# Casey Fields South Employment & Devon Meadows PSP & Amendment C295case

**Issued**  
31 March 2025

Beveridge Williams has prepared this submission to the Casey Fields South (Employment) and Devon Meadows Precinct Structure Plan (CFSDM PSP) and associated Amendment C295case on behalf of the Devon Land Pty Ltd who is the developer associated with the land at 85 Devon Road, Devon Meadows. The 3.96 hectare site is centrally located within the Devon Meadows precinct and is currently used as a market garden.

Figure 1: Extract from PSP Plan 2: Place Based Plan (VPA 2024)

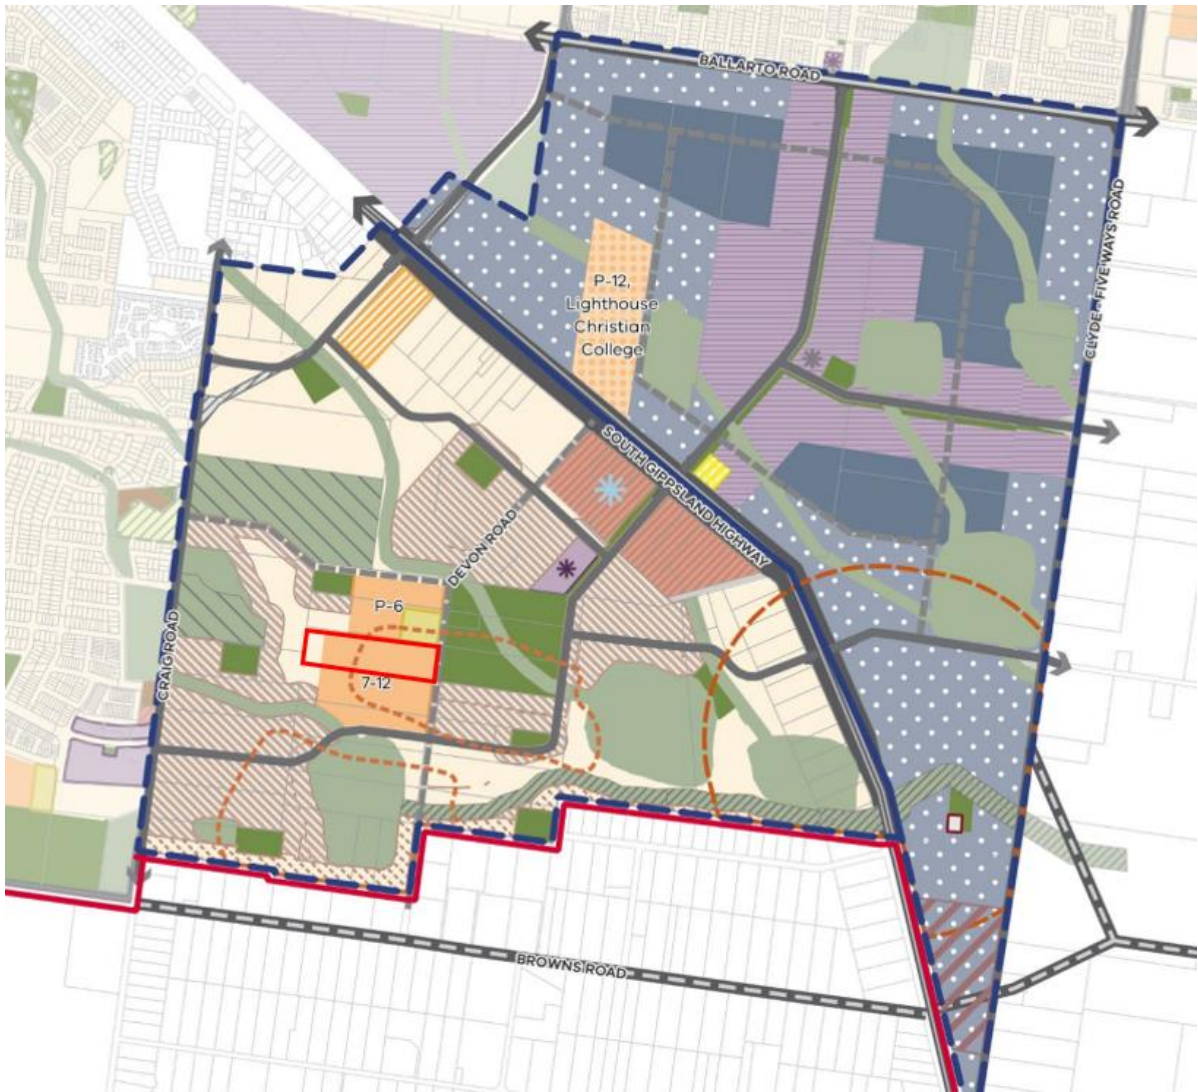
The draft CFS&DM PSP identifies a government secondary school across the majority of the site. Standard residential development is proposed on the small portion of remaining land located at the rear of the property.

The subject site is centrally located within the Devon Meadows precinct and is identified as property ID# DM44. The draft PSP indicates that the subject site will support a government secondary school on the majority of the site with a small amount of standard residential density development making up the remainder.

Despite the points raised above, the PSP designates a government secondary school over a large portion of the site. The proposed school would span across parts of two other properties, which is generally not ideal. It is understood that the Department of Education prefers to locate schools on a single property whenever possible. This raises the question of why the proposed school is positioned in its current location. A review of the technical assessments and background reports that have informed the outcome of this PSP suggests that the school was placed in its current position to avoid various encumbrances, such as potentially contaminated land, future drainage alignments, separation buffers (to the extent practical), and to support an efficient road network. Given these constraints, it is submitted that there are few available sites large enough to accommodate the proposed school.

It is submitted that establishing two new secondary colleges across the two PSPs is unnecessary, as a single school would adequately serve both precincts, and better respond to the lack of demand within the CFS&DM PSP and likely the Clyde South PSP also. It is therefore submitted that the proposed school site should be removed from the subject land and relocated to the future Clyde South residential precinct.

Figure 5: Existing school catchment (orange), VPA proposed (blue) and BW proposed catchment area to capture Clyde South residential PSP (green).

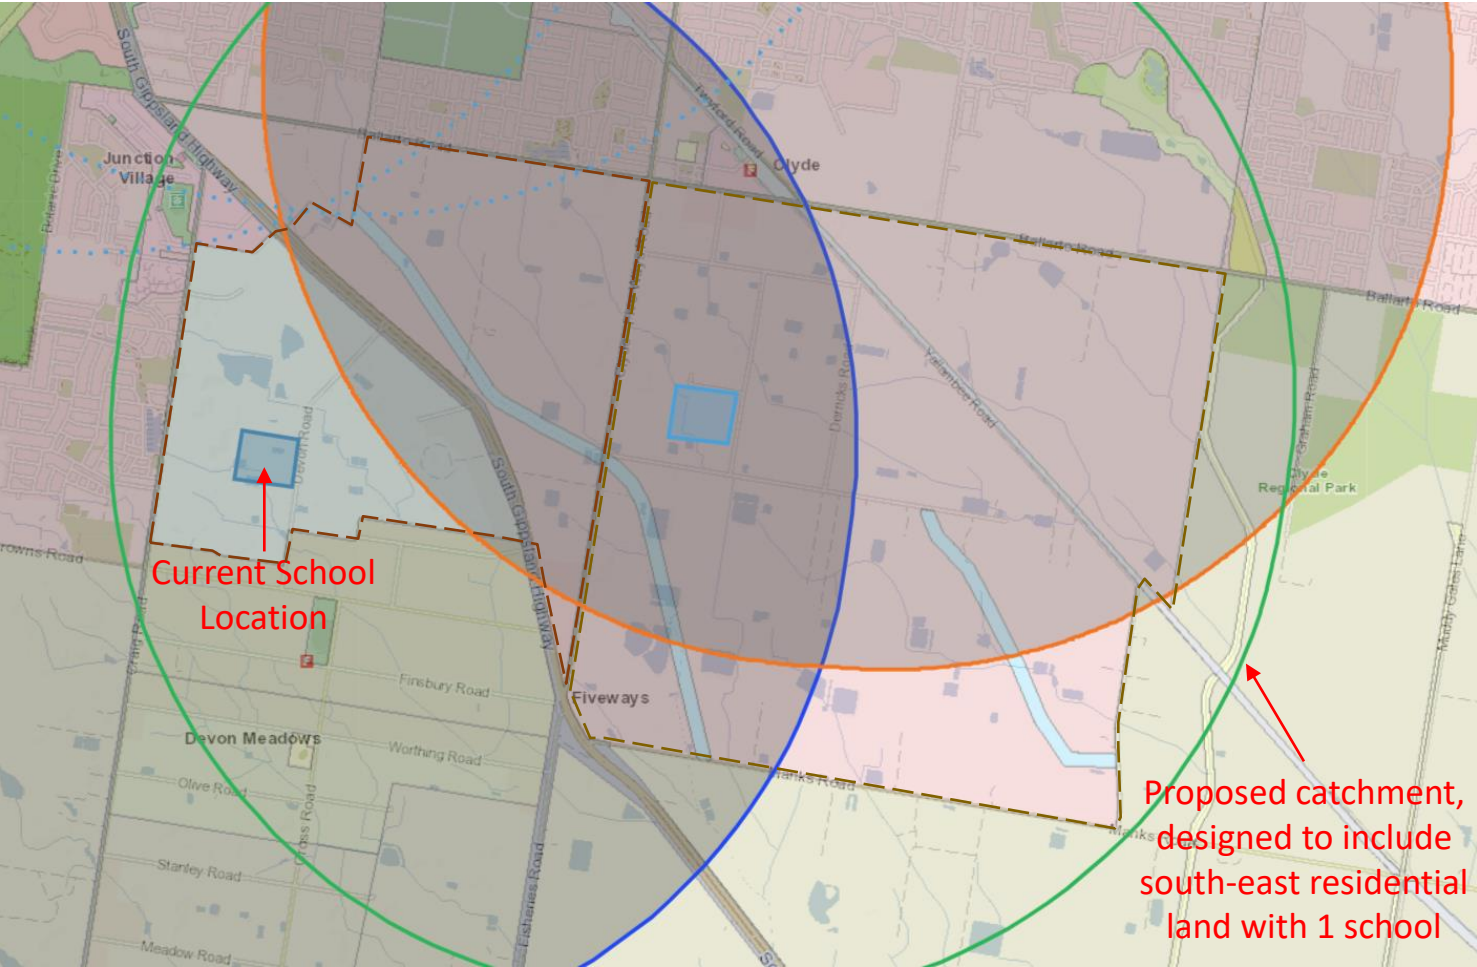
Figure 5 identifies the current school location within the CFS&DM PSP and shows the 3200m catchment area in blue. The current proposed placement of the school results in the south-eastern portion of the Casey Fields South PSP being outside of the 3200m coverage area. The image also highlights the existing Clyde Secondary College catchment (in orange), which extends well into the Clyde South PSP and partially into the CFS&DM PSP areas. The broad reach of this catchment may help explain the low demand observed within the CFS&DM PSP, and it also suggests that there may be a similar low demand for a secondary school within the Clyde South precinct.

It is evident that due to the current proposed placement of the secondary college on our client's land, an additional secondary college will be required within the Clyde South PSP to service the future residents of that precinct.

Relocating the proposed secondary school would provide a net community benefit by including the neighboring Clyde South precinct in the future school catchment. This move would also reduce asset requirements and land allocation, making more efficient use of infrastructure. Supported by the low demand observed within CFS&DM, this approach suggests that a single school would attract more students, enabling it to offer a broader range of curriculum options compared to two under-attended schools.
